Friday 22nd July, 2022

Angus Place West (EPBC Ref# 2022/09270) should be a Controlled Action

Piezometers indicating no water in swamp in an EIS, claimed not to be an indicator of swamp damage in Centennial Angus Place proposal to extend the mine further east under Newnes Plateau.

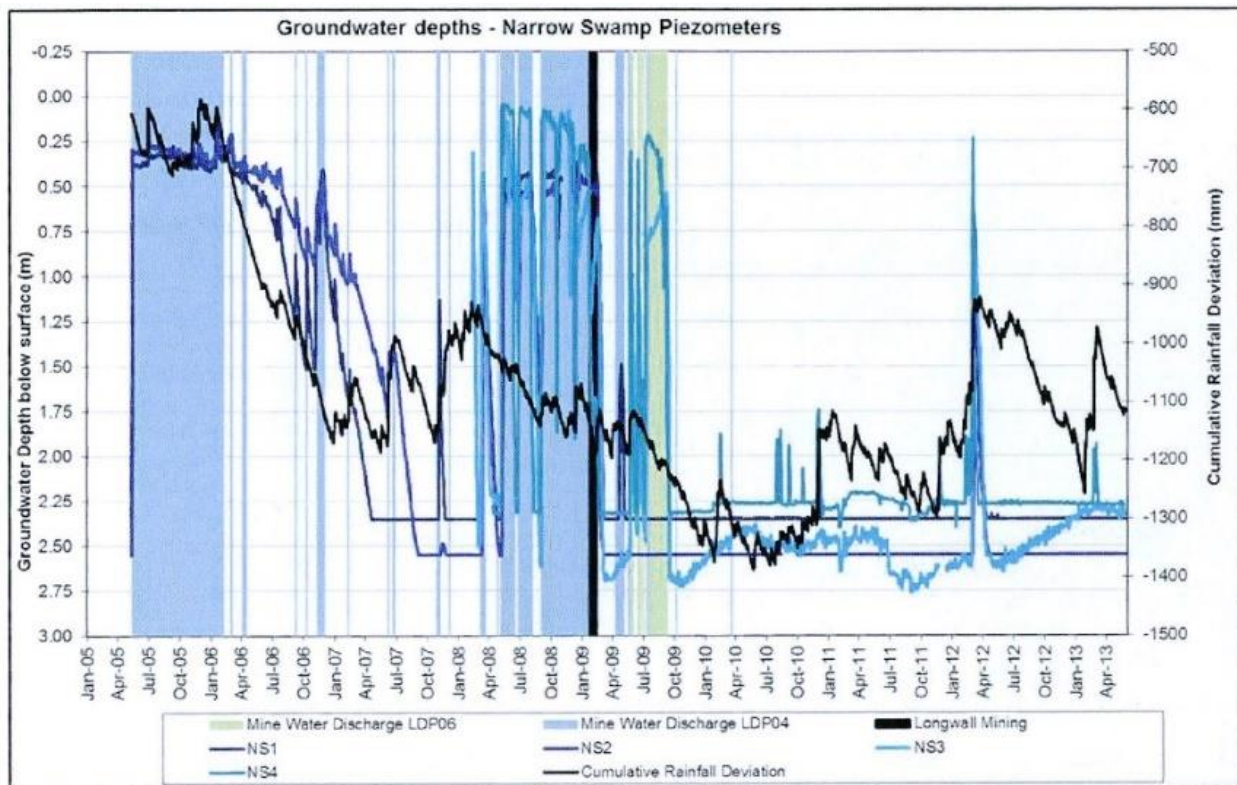
June 2005 – April 2013: The hydrographs of the four piezometers in Narrow Swamp in Figure 8.5 for the Angus Place [east] extension proposal (EIS Vol. 1, page 228 – reproduced below) reveal that the 'bottom of the hole' groundwater level trends continue for these bores at least till April 2013. Yet in this mine extension EIS Centennial Coal denied its mining had any impact on this swamp.

Figure 17 - Location of Groundwater Observation Bores and Geological Structures

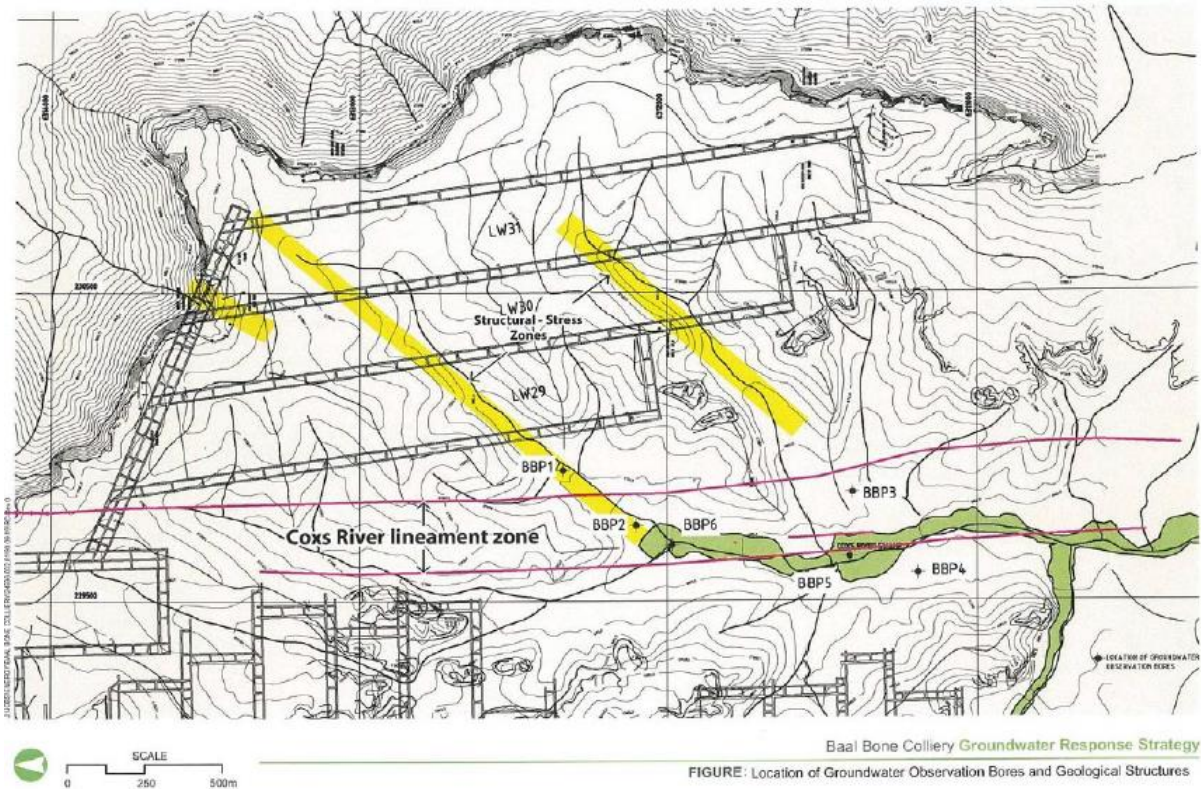
Coxs River lineament zone is indicated here by Baal Bone mine as approximately 200 metres wide, so setbacks proposed by Centennial Coal are inadequate and the mine will drain Long Swamp.

When Centennial's first workings approach the river and intersect the fractured strata associated with this fault, far field drawdown of near surface groundwater can be expected to drain nationally endangered Long Swamp. Mining under Kangaroo Creek can be expected to have similar consequences to its swamp due to other lineaments. From the above figure, the setbacks proposed by Centennial shall be insufficient to prevent water losses.
